Distribution:**TO:** All Districts, Branches, Service Branches and Dealers**SUBJECT:** Super EZ-AO Chain Saws**DATE:** 1-77**UNITS AFFECTED:** SEZ-AO-16" PT/ST - S/N 43130939 thru 43134558
CG SEZ-AO-16" PT/ST - S/N 40346179 thru 40347417**PARTS AFFECTED:** Drivecase Cover #65131-15 (Latest Revision)**PROBLEM:** Drivecase Cover Distorts Outer Guide Bar Shim #67299-A
Causing Chain To Strike Shim In Operation.

Distribution:**TO:** All Districts, Branches, Service Branches and Dealers**SUBJECT:** Revised Occupational Safety and Health Act (OSHA)
Standard 1910.309 (c) and 1926.400 (h).**DATE:** 2-77

Distribution:**TO:** All District, Service, Branch and Parts Managers.**SUBJECT:** 111B1 Blowers**DATE:** 2-77

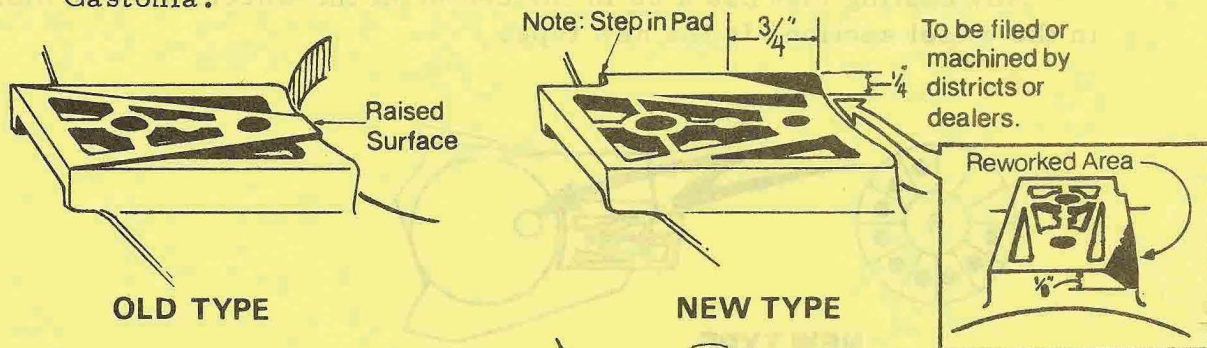
The New Wider Pad Drivecase Covers packed with the above Serial Number Saws are oversize on the pad and will overlap the flat portion of outer shim #67299-A that is required for the -D3 narrow guide bar.

This overlap will cause the shim to distort so that the chain will strike it in operation.

- a. The Drivecase Covers involved will be filed or machined by the Districts or Dealers to the dimensions shown by shaded area in sketch.

The shim should be tried on each re-worked Drivecase Cover to see it sets flat when mounting holes are lined up.

SUBJECT: Wire Tie # 50729 - Ignition Module

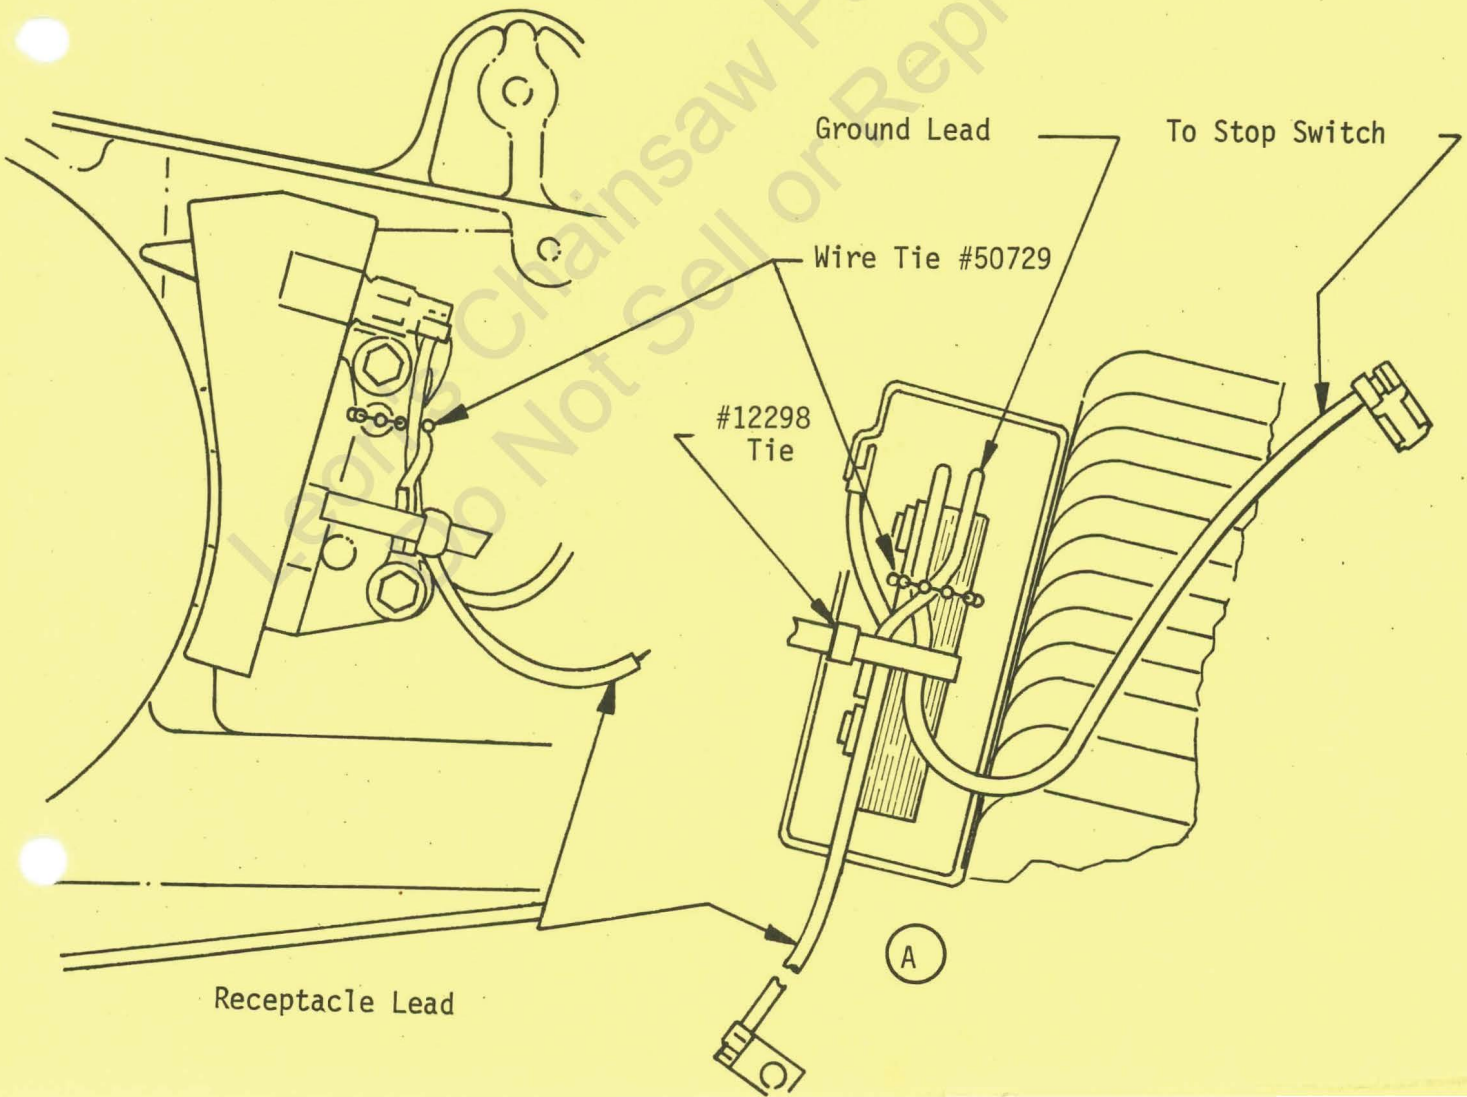
To prevent the ground lead breaking, we added an additional wire tie # 50729 (beaded nylon) to the ignition module. This wire tie is added above the existing nylon band tie to prevent movement of the ground leads and stop switch lead.

The installation of the new wire tie is shown in the sketch below.

Order a supply of these wire ties to install on existing saws when they come in for service.

Figure 2

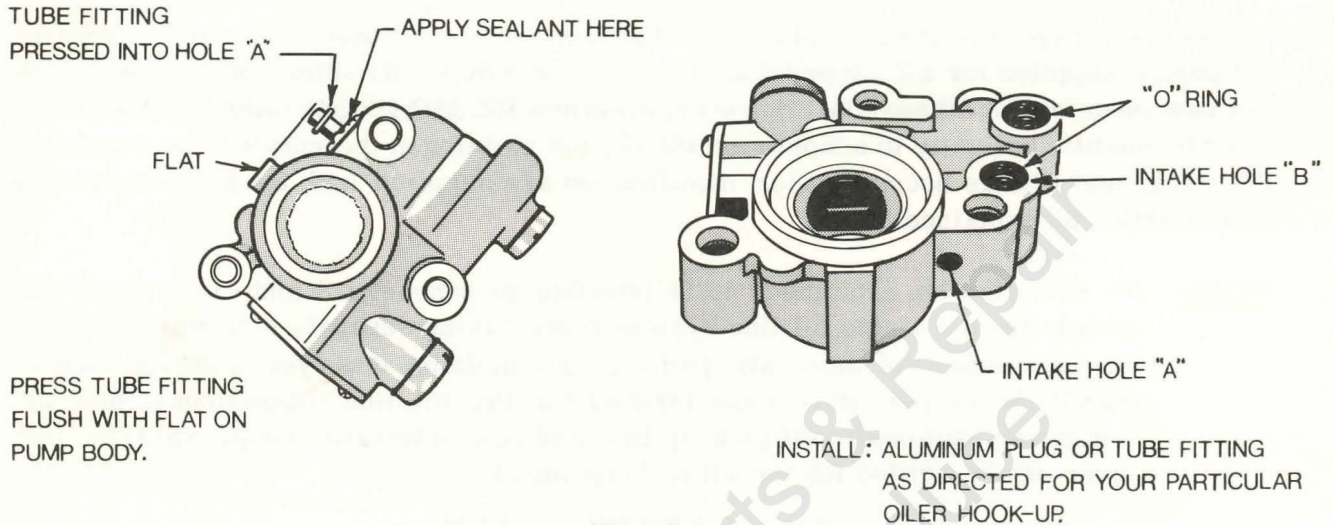
2. If the new automatic pump A-65212-B is being installed, plug hole "A", shown in Figure 2 with the aluminum plug supplied with the pump assembly. In this modification the tube fitting that also comes with the pump will not be used. Complete your reassembly of the saw, and check the flow from both the manual and automatic pumps.

Figure 3

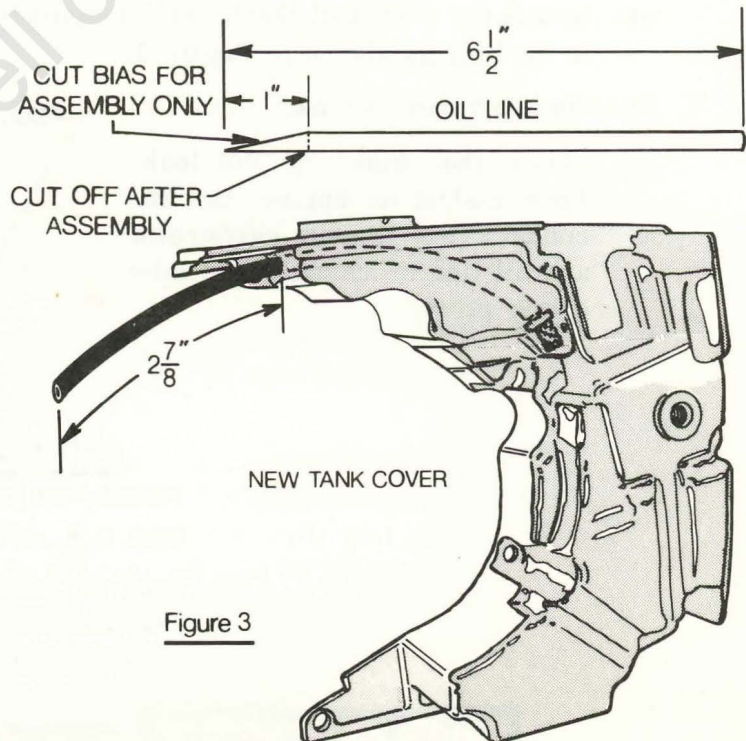
1. These Super EZ models from SN 42042785 have a separate pick-up and oil line in the existing oil tank cover. When installing the new cover assembly A-69832, install the pick-up A-65172 and oil line 69755 in the cover before securing the cover to the tank. The duck-bill check valve supplied with the new cover is not installed in this case, but can be saved as a replacement for the fuel cap check valve. Refer to Figure 3 for positioning of the oil line in the cover.

Figure 4

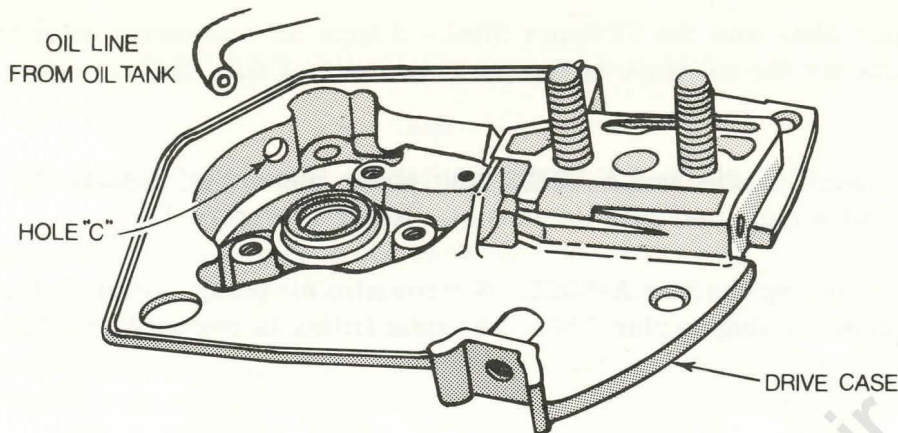
2. When assembling the tank to the saw, put the oil line through hole "C", (figure 4) in the rim of the drive case.

SPROCKET AND CHAIN MATCH-UP SHEET

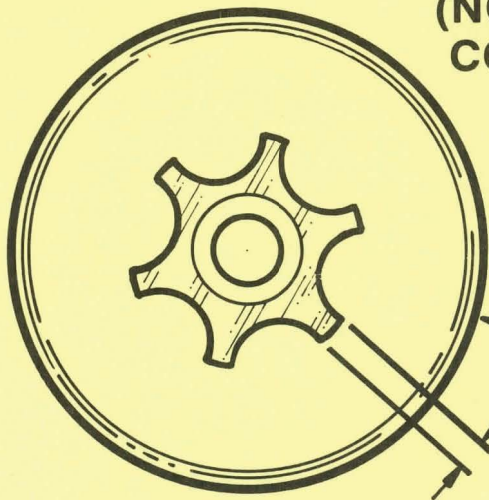
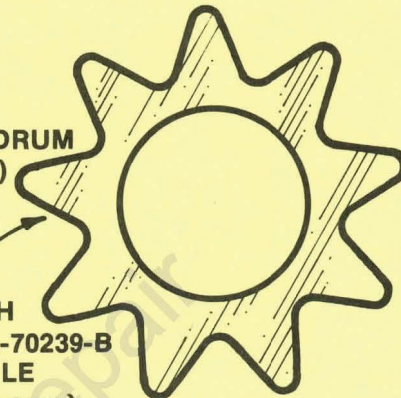
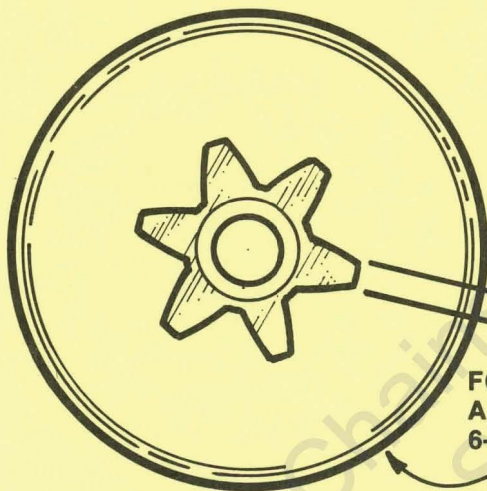
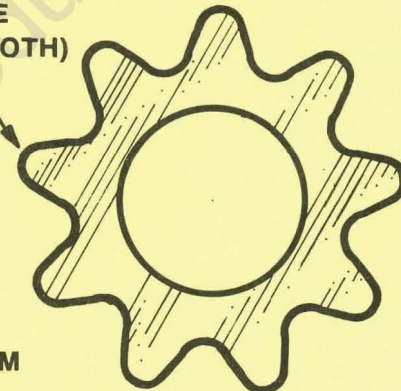
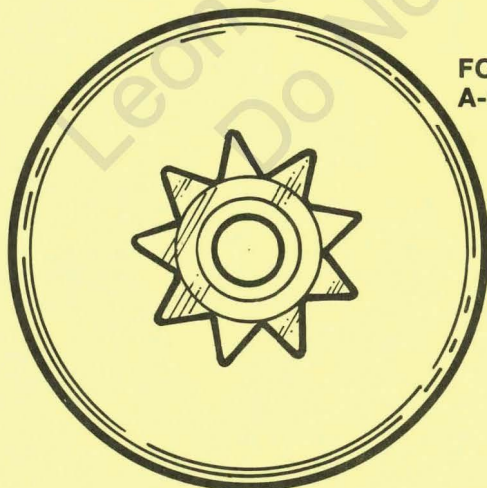
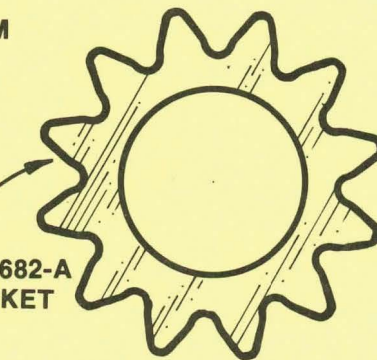
All Third Generation saws built with, or saws in the field modified with A-70221-A clutch sprocket and A-70239-B nose sprocket can use either 37 or 375 chain.

Illustration of the muffler A-93686 and part numbers are listed below.

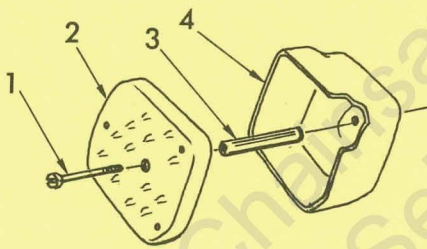
Initially the muffler cap was welded to the muffler body and the assembly attached to the cylinder by means of a socket head screw.

New muffler A-93686 utilizes a through bolt and spacer to retain the muffler cap and muffler body to the cylinder.

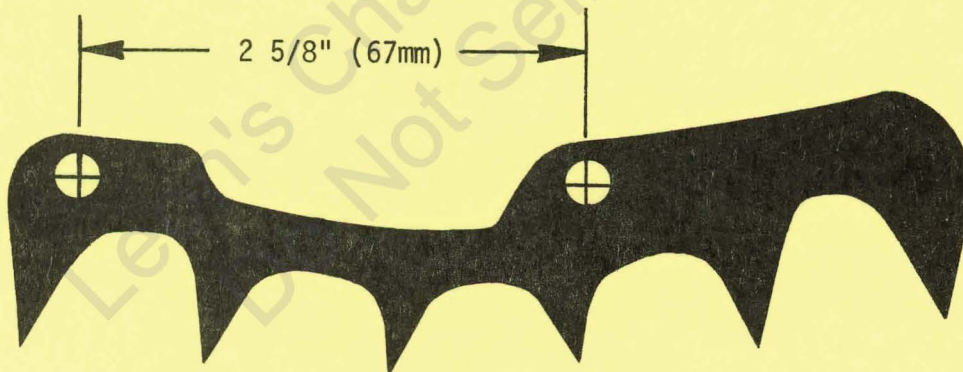
The Spiked Bumper of part number A-59043 should look like this:

In error we have packaged Spike Bumpers which look like this:

The part with the mounting holes close together is actually from A-65181 which fits model SEZ and SMini series of saws. (The screws in the packages can be used on either XL-12, SXLA0 or SEZ and SMini).

Please check your stock and correct as necessary.

Figure 1—Diagram of the New XL Pressure Feed Chain Oil System.

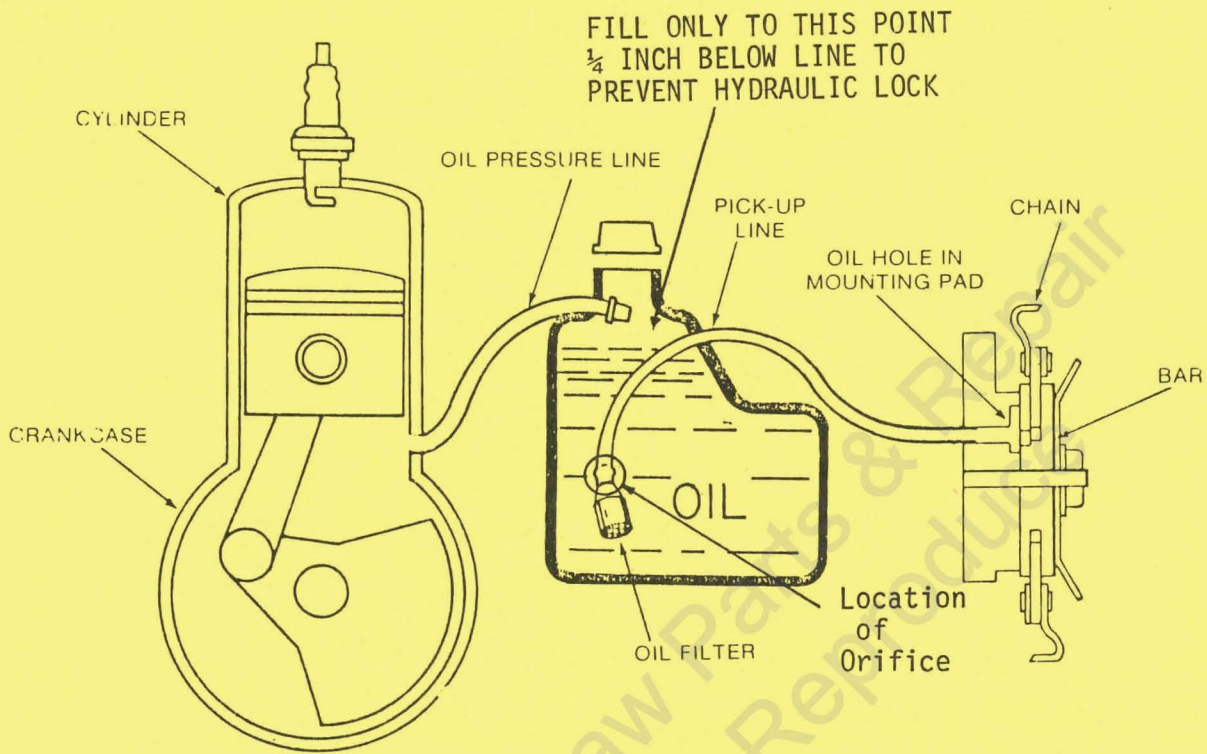
A new oiling system has been incorporated into the XL saw. This system uses pressure from the crankcase only. No diaphragm is necessary. The oil is pumped directly from the tank to the guide bar pad. See Figure 1.

Figure 2—Cleaning the Chain Oil Pick-up Line Filter and Orifice

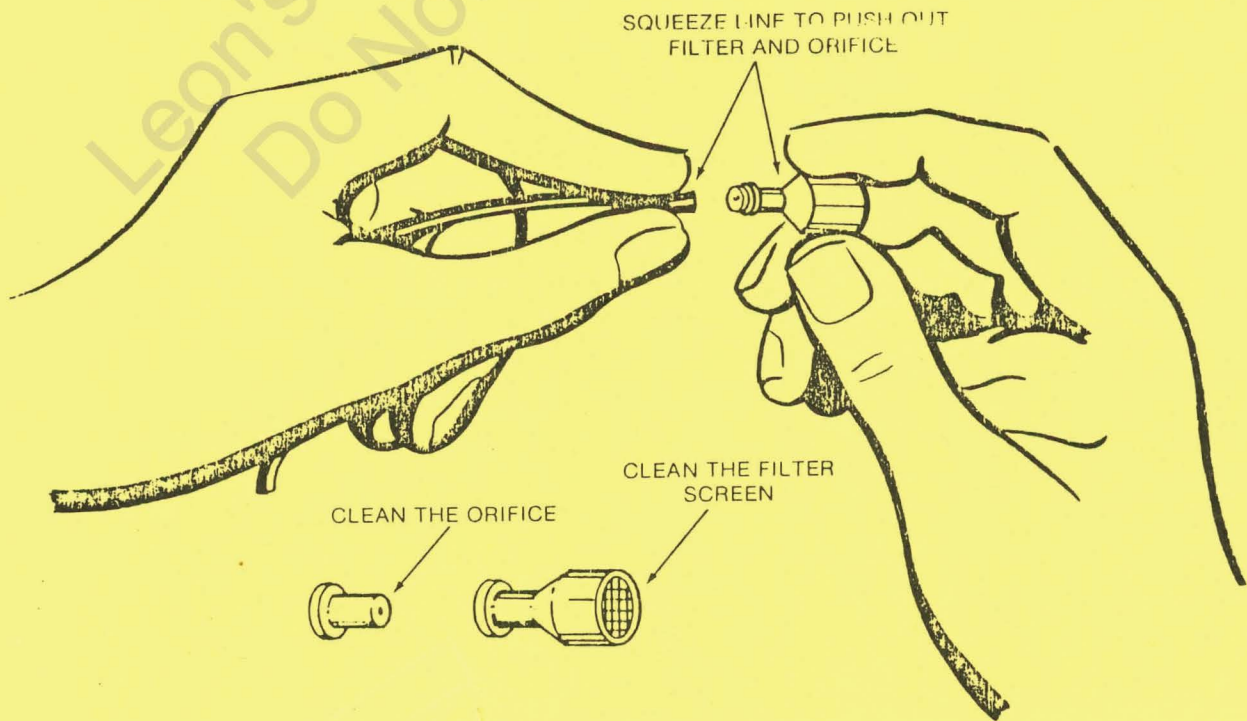
Note: Orifice part number 93703 is only a metering valve. It is not a check valve, the orifice can be cleaned with an appropriately small diameter straight pin or sewing needle. Orifice is $\frac{.024}{.026}$ in diameter. See Figure 2.

DRIVECASE COVER

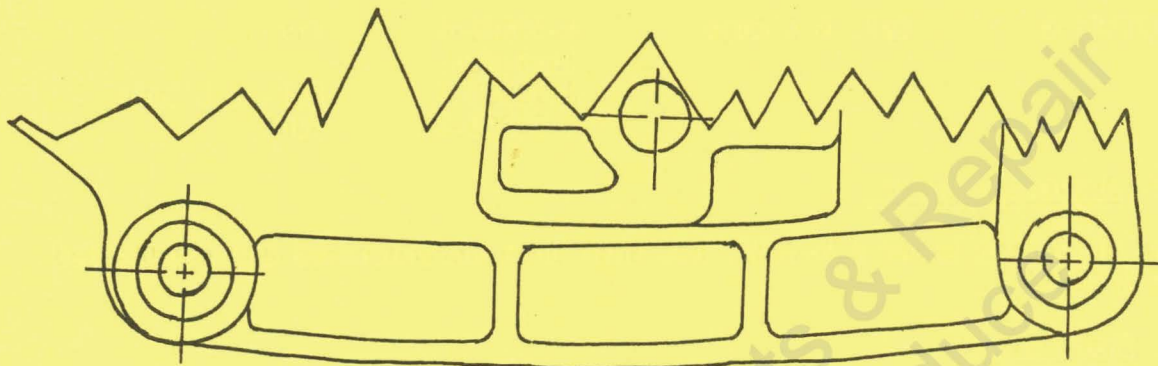
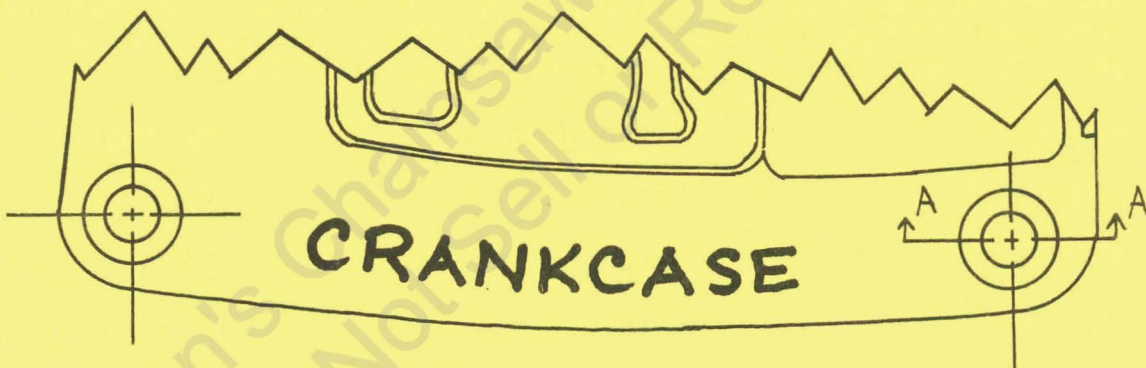
To prevent this from occurring will require a design change in the mounting area and the type of fasteners now being used.

- A. Counterbore the two mounting holes for the bumper spike on the sprocket side of the drivecase and drivecase cover. Use a $\frac{1}{2}$ " diameter counterbore to provide a flat assembly surface for the new button head screw. Depth of counterbore should be such that it will just barely remove the cast countersink and approximately $\frac{1}{8}$ " thickness will remain from the bottom of the counterbore to the bumper spike mounting surface. See sketch attached.
- B. Replace the two flat head screws # 80173-1 with two button head screws # 80963 (12-24 x $\frac{1}{2}$ ").
- C. Add the two lock washers # 70901 under nuts # 81068.
- D. Replace the two lock nuts # 81204 with hex nuts # 81068.

NOTE: If screw # 80963 is not available, screw # 80821 may be reworked by grinding the head height to 9/64" maximum to provide clearance between screw head and chain.
